Planning and Zoning Board

ZONING CASE#: Z15-026
LOCATION/ADDRESS: The 7400 to 7600 block of East Southern Avenue (north side)
GENERAL VICINITY: The northwest corner of Southern Avenue and Sossaman Road
ZONING REQUEST: Rezone from LC PAD PAD to RSL-2.5 PAD PAD and site plan/preliminary plat
PURPOSE: This request will allow the development of a single residence subdivision with 81 lots
COUNCIL DISTRICT: District 5
OWNER: The Arizona Real Estate Fund II, LLC
APPLICANT: Sean Lake, Pew and Lake, PLC
STAFF PLANNER: Lesley Davis

Proposed 81 lot subdivision

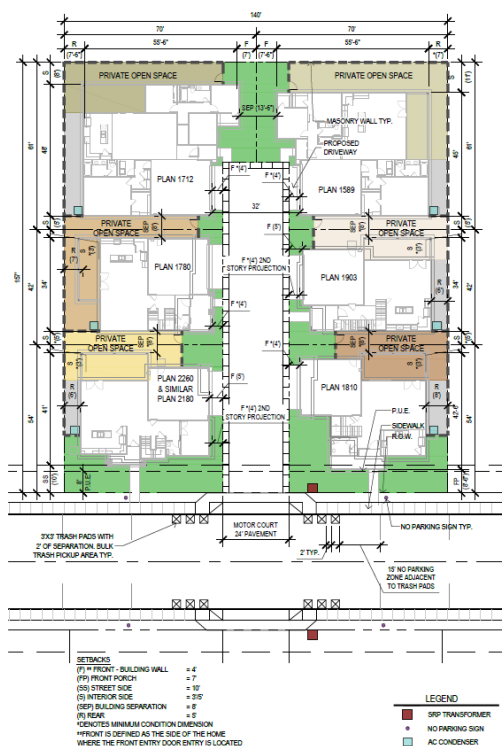
The Mesa 2040 General Plan states that uses within the Mixed Use Activity District, the appropriate uses should include retail areas and entertainment centers, but often also include offices, multi-residential and other supporting uses. Multi-residential or office seem to provide a more graduated transition, perhaps offering a bit more open space adjacent to the residential to the north. As proposed those homes will have many two-story homes that are very close to their rear property lines. The proposal also

puts single residences directly adjacent to a corner gas station. Landscaping has been provided as a buffer, but it still raises the question that this housing type with such large building footprints may not be appropriate in this location. The proposed development is shown below.

The Neighborhood Chapter of the General Plan designates six key elements to the design of neighborhoods. This site design does a reasonable job of meeting most of those elements.

Setback and Open Space Exhibit

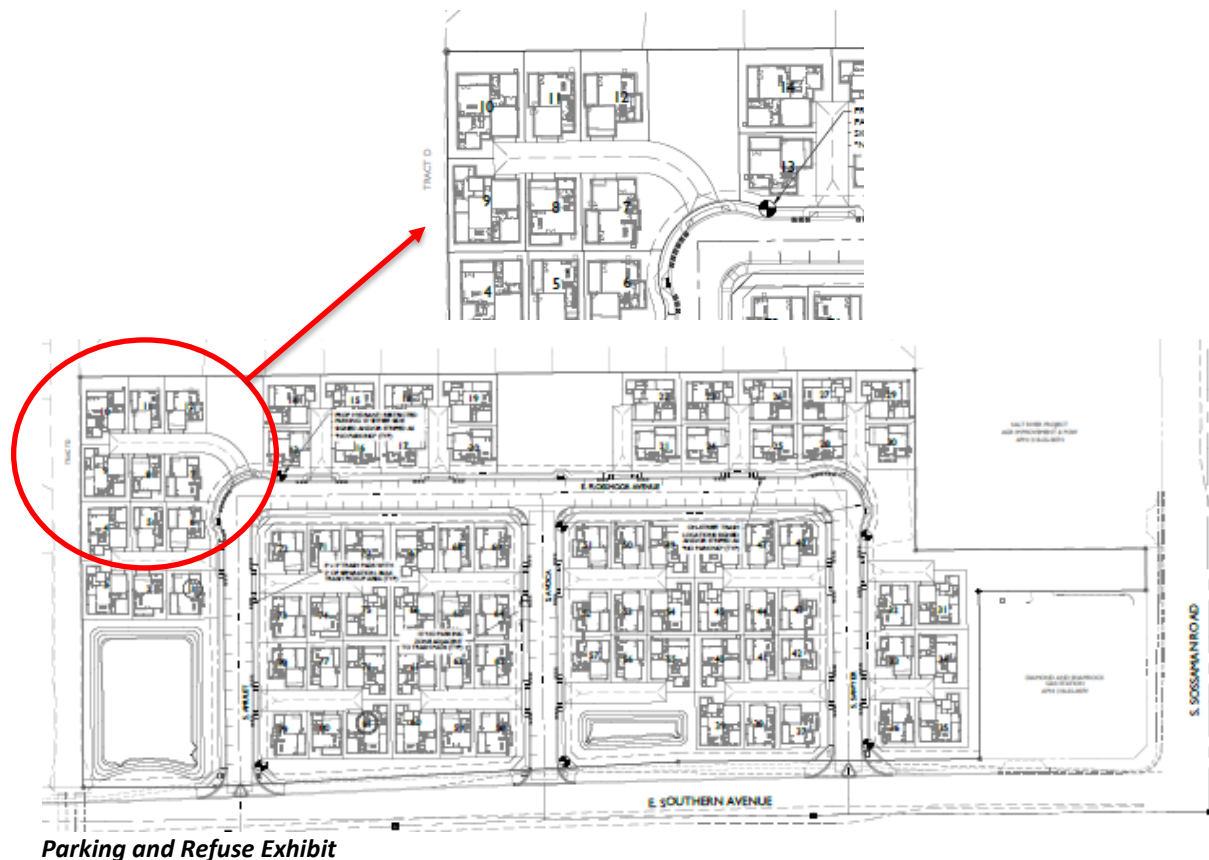
This product is approved for two other recently approved subdivisions in Mesa and staff has recently been able to see this product constructed and experience the reality of the 5-foot rear setback. Staff is concerned that the reduction from 15-feet to 5-feet may be too severe. The 5-foot setback coupled with this housing type creates a scenario where there could be as many as 12 homes backing up to one another, from two adjacent clusters, with a maximum of 10' between the homes for that entire row. This happens in two locations within this proposed subdivision. The applicant has committed to a reduced second floor footprint to help reduce the canyon effect that these long rows of two story homes creates, but more variation in that setback may be necessary to provide some relief and space between homes to make it a more livable and comfortable community long term.

The exhibits below depict the proposed setbacks for each cluster as well as depicting the commitment from the applicant that the sum of the walls for the homes within 10-feet of the rear property line will not exceed 55% of the outside length of the pod/cluster. The private areas are shown in the exhibit on

the left, with the brown, tan and yellow spaces, while the green area is the public open space. The second exhibit on the right, identifies the single-story (purple) vs. two-story (tan) portions of the home. It is important to note that the homes at the end of each cluster have the potential to be two story homes, which has not been represented in the exhibit.
